Staff Report to the Zoning Administrator

Application Number: **111073**

Project Description: Proposal to construct a two-story single-family dwelling, attached carport and garage totaling approximately 3,800 square feet, and to remove and replace, in kind, the surface deck of an existing bridge. Project includes grading of approximately 375 cubic yards cut and 225 cubic yards of fill.

SITE PLAN

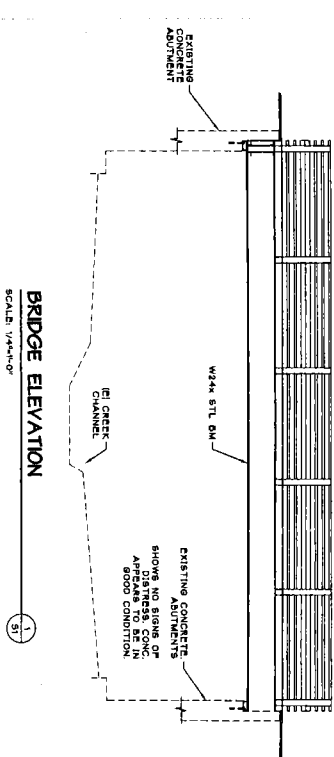
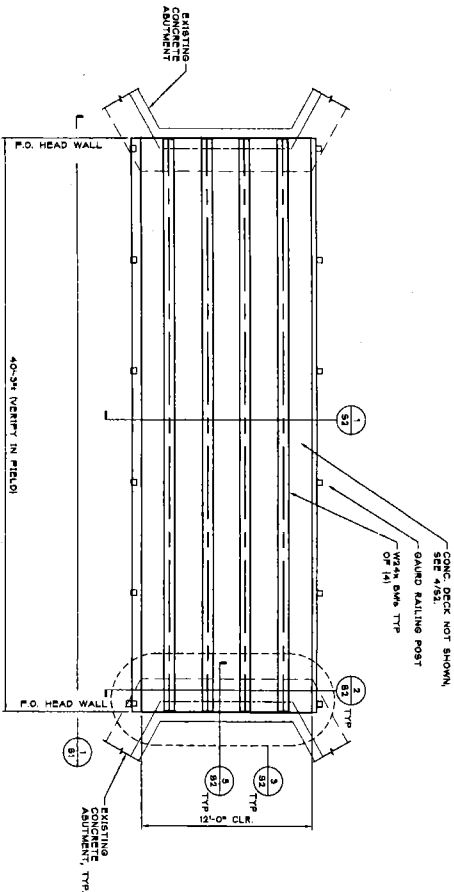
The title sheet shows conflicting figures for parcel size, gross lot area and net lot area. The net lot area should equal the gross lot area less the area of the unnamed right-of-way that crosses the lot.

Please clarify and revise if necessary.

BRIDGE PLAN

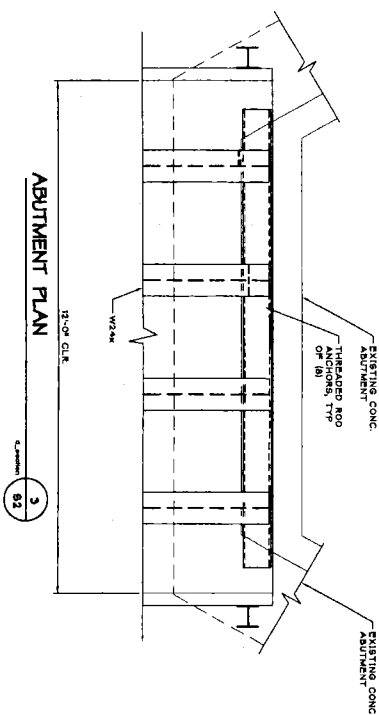
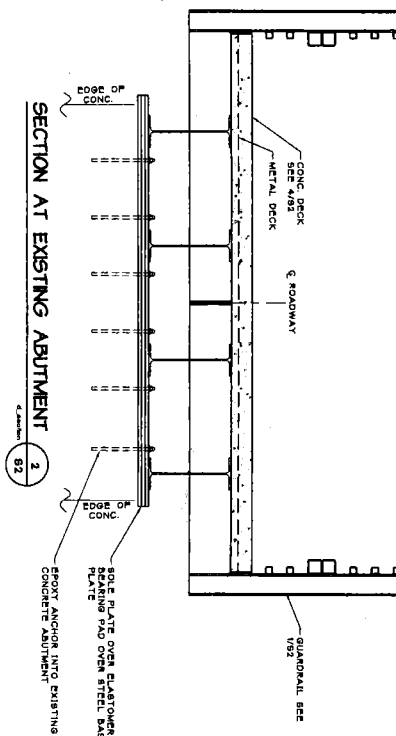
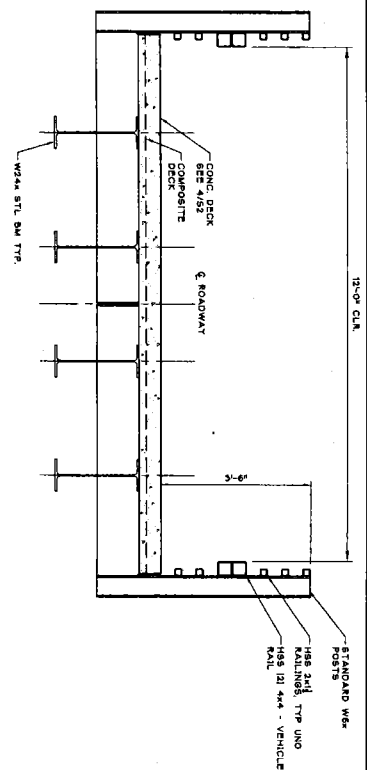
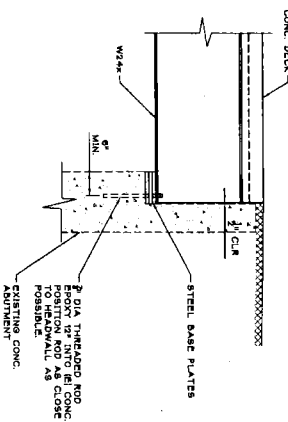
You are requesting that we allow you to replace the existing (non engineered) bridge decking with new decking that can be certified by an engineer to meet the HS-20 loading standard without widening the existing bridge. We would be willing to accept this request with several conditions:

2. Grading, drainage, and erosion control plans.
 3. A detailed plan showing the proposed bridge decking and rail replacement. The plan shall clearly indicate the location of the crane operation and staging areas, as well as all other equipment and materials staging areas needed in support of the bridge repair.
